## Commission of Architectural Review

| 1. COA-172313-2025   | Final Review <span style="float: right;">Meeting Date: 9/23/2025</span>   |
| Project Description  | Repairs and expansion of rear porch.  |
| Address: 2605 East Franklin Street   |   |

Figure 1: photos submitted by applicant

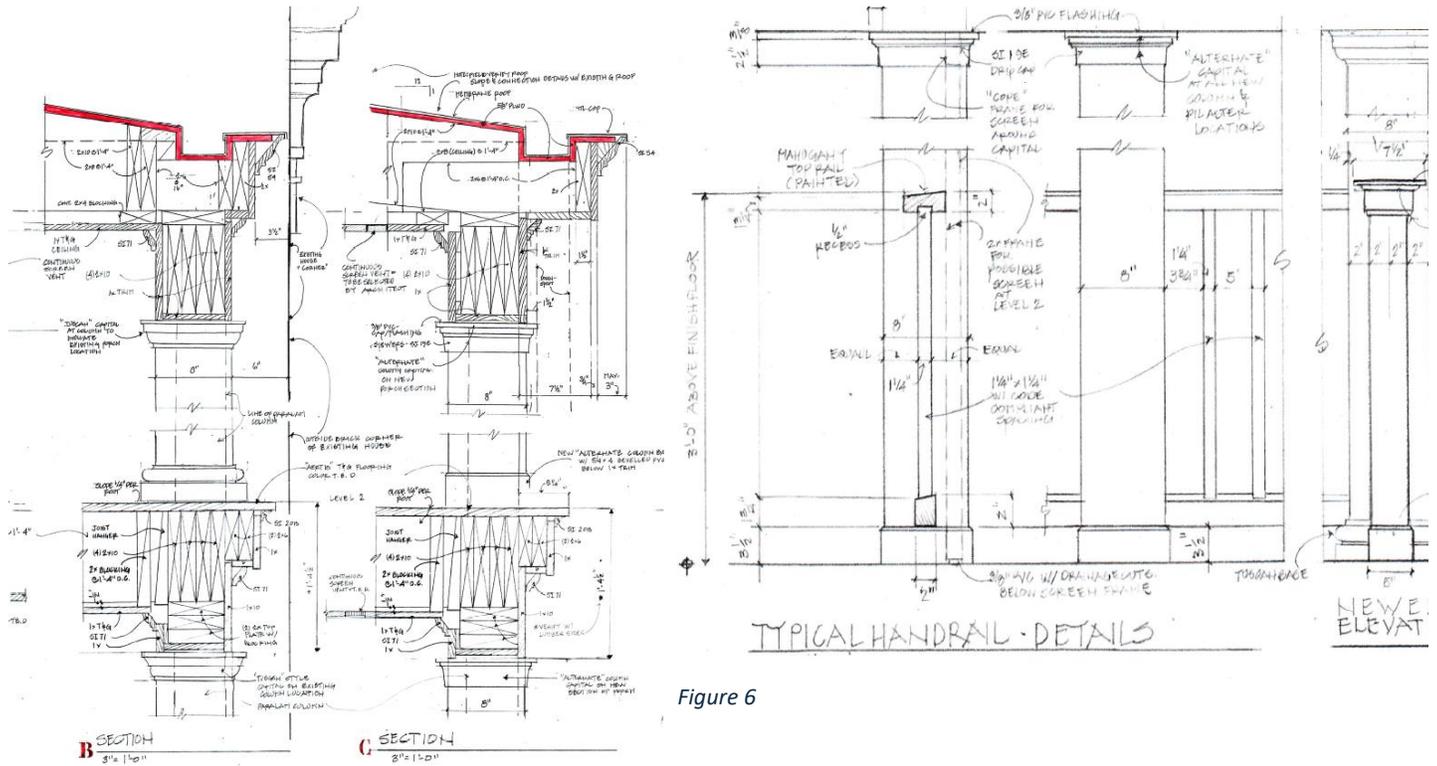
| Guideline Reference  | Reference Text   | Analysis   |
|--|--|--|
| The Secretary of the Interior, Standards for Rehabilitation, pg. 4 | <p><i>2. The historic character of a property shall be retained and preserved. The removal of historic materials or alteration of features and spaces that characterize a property shall be avoided.</i></p> <p><i>5. Distinctive features, finishes and construction techniques or examples of craftsmanship that characterize a property shall be preserved.</i></p>                       | <p>To identify the extent of the original porch, the Tuscan base and capital are retained at the existing columns. In the extended portion, an alternate design is used at the base and capital of the new columns, which provides an appropriate visual distinction between the new and historic material. Projecting pilasters are added to the existing wall, with alternate capitals that match the design of the new addition.</p> <p>Additionally, new brick paving incorporates a brick column pattern at the original pier location, creating a legible interpretation of the historic footprint.</p> <p>These elements help preserve the historic reading of the original porch, while allowing for a compatible extension that is clearly identifiable as a new addition.</p> <p><u>Staff recommends approval of the use of differentiated column, pilaster, flooring and paving treatments to maintain legibility of the original porch.</u></p>                  |

| Staff Recommendations  | <p>Staff recommends approval of the proposed porch extension and repairs, with the following conditions:</p> <ul style="list-style-type: none"> <li>Any in-kind replacement materials match existing in profile and dimension, and that replacement be limited to areas with documented deterioration</li> <li>All installations be carried out in a manner that minimizes impact to existing historic fabric, particularly where new elements interface with original porch framing and columns</li> </ul> |
